MAHARASHTRA METRO RAIL CORPORATION LIMITED
(Jointly owned company of Government of India and Government of Maharashtra)
Clarification
TENDER NO.: Tender No. N2-057/RS-01/2025, Dated 07.03.2025

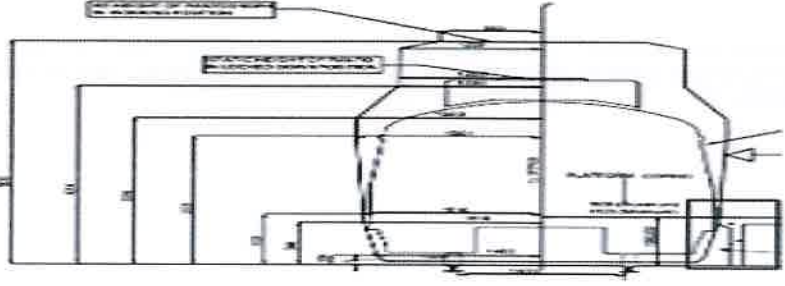
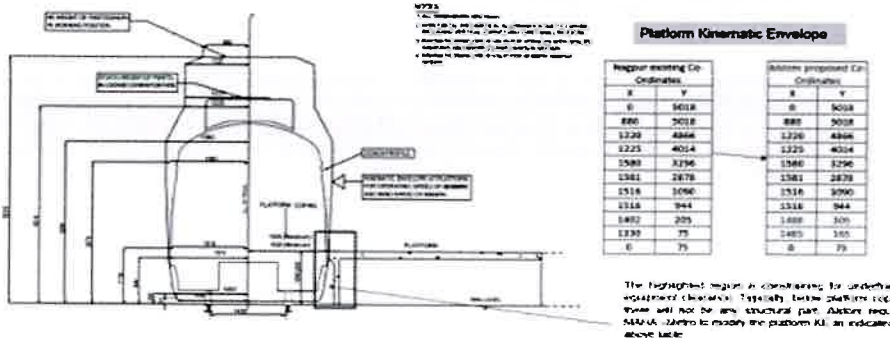
267	Part 2 Works Requirement - Technical Specification	5.6.2	The bogie frames shall be able to withstand a longitudinal shock load of 5g without failure. This shall be taken as occurring simultaneously with the fully laden vertical load.	Justification: AT follows EN13749 for loads on attachments. UIC 615-1 primarily implies loads on Bogie Frames for structural strength. As per EN13749, Longitudinal Shock load of 3g for Motor Bogie & 5g for Trailer Bogie Amendment Requested: The bogie frames shall be able to withstand a longitudinal shock load of 3g for Motor Bogie & 5g for Trailer Bogie without failure. This shall be taken as occurring simultaneously with the fully laden vertical load.	Tender condition Prevails
